Product / Process Change Notification (PCN)

PCN Number: PCN_WCAP-FTBE_20240930

Affected Series: WCAP-FTBE

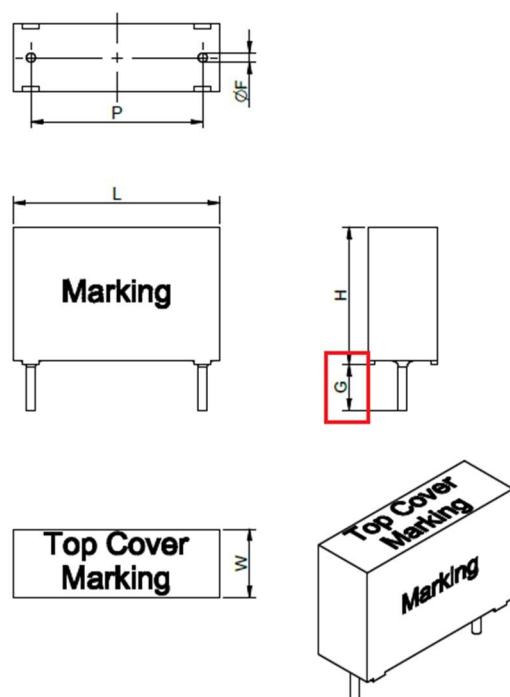
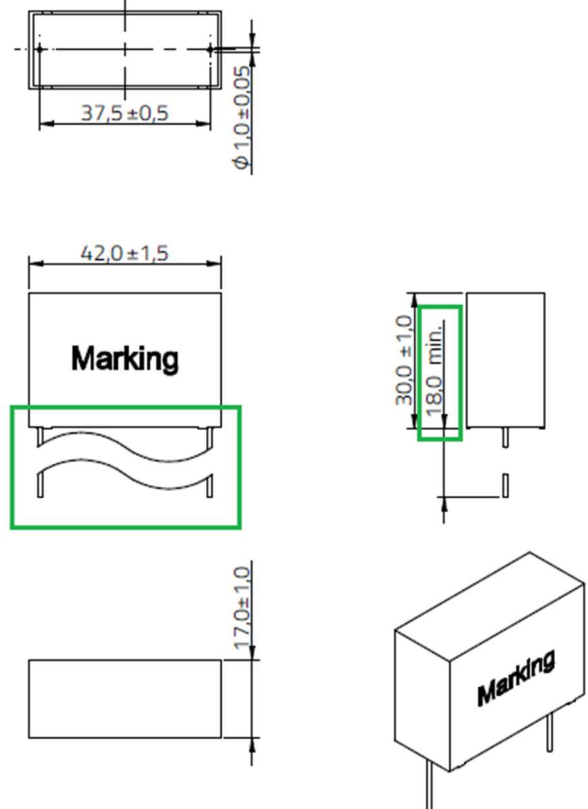
1.1 Würth Elektronik eiSos will update the dimensioning from an **indirect dimensioning** to **direct dimensioning**. The table will be removed and all dimension values will be shown directly in the drawings.

And the **“Top Cover Marking”** will be removed based on the new marking, details will be explained in 2.
